**BROWNS FERRY NUCLEAR PLANT (BFN) - UNITS 2, AND 3 -  
RESPONSE TO NRC's ACCEPTANCE REVIEW LETTER AND REQUEST  
FOR ADDITIONAL INFORMATION RELATED TO TECHNICAL  
SPECIFICATIONS (TS) CHANGE NO. TS-418 – REQUEST FOR  
EXTENDED POWER UPRATE OPERATION (TAC NOS MC3743 and  
MC3744)**

**REPLY TO RESULTS OF ACCEPTANCE REVIEW AND REQUEST FOR  
ADDITIONAL INFORMATION FOR BFN UNITS 2 AND 3  
EXTENDED POWER UPRATE APPLICATION  
(Proprietary Version)**

#### EXTENDED POWER UPRATE RS-001 REVISED TEMPLATE SAFETY EVALUATION

**SIL 644 Supplement 1  
Basic GE Steam Dryer Hood Types**

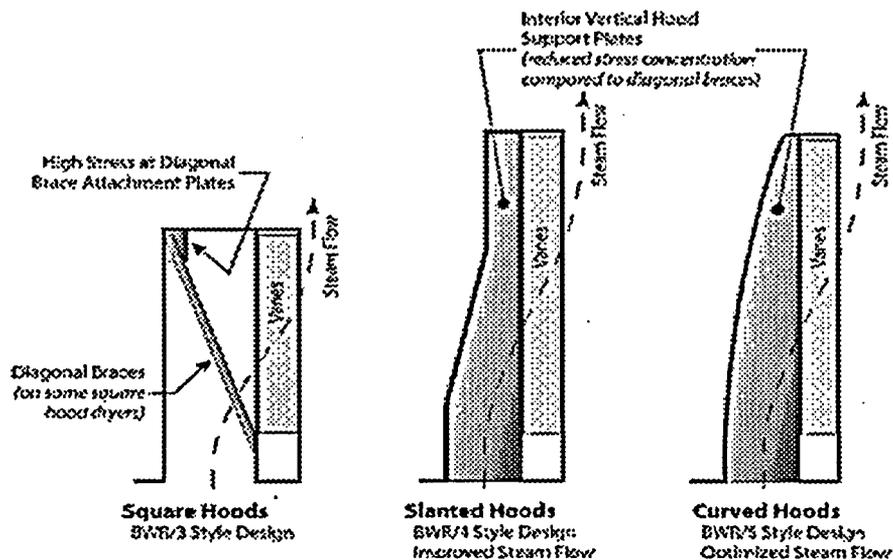
The Dresden and Quad Cities plants are BWR3 designs which utilize a steam dryer design with square end hoods, making them more susceptible to adverse loading conditions than the BFN BWR4 design with slanted steam dryer end hoods. The BWR4 hood design incorporates a slanted hood face section and additional dryer bank stiffener plates, which provide significantly more restraint to the hood face over and above the BWR3 design.

**NRC Request 5.a.(1)**

- Additional reinforcement of the existing cover plate 1/4 inch fillet weld to attain a full 3/8 inch fillet weld.
- A gusset on each dryer hood face is planned that will provide additional reinforcement to the cover plate and hood face. The height of the added gusset will be optimized based on the most mitigating configuration for reducing overall dryer stresses, improving flow straightening contributions and dose reductions for the underwater divers implementing the modifications. Welded attachments to the existing dryer components will invoke the objective of minimum weld stress design approach by increasing the weld area and minimizing weld stress concentrations.
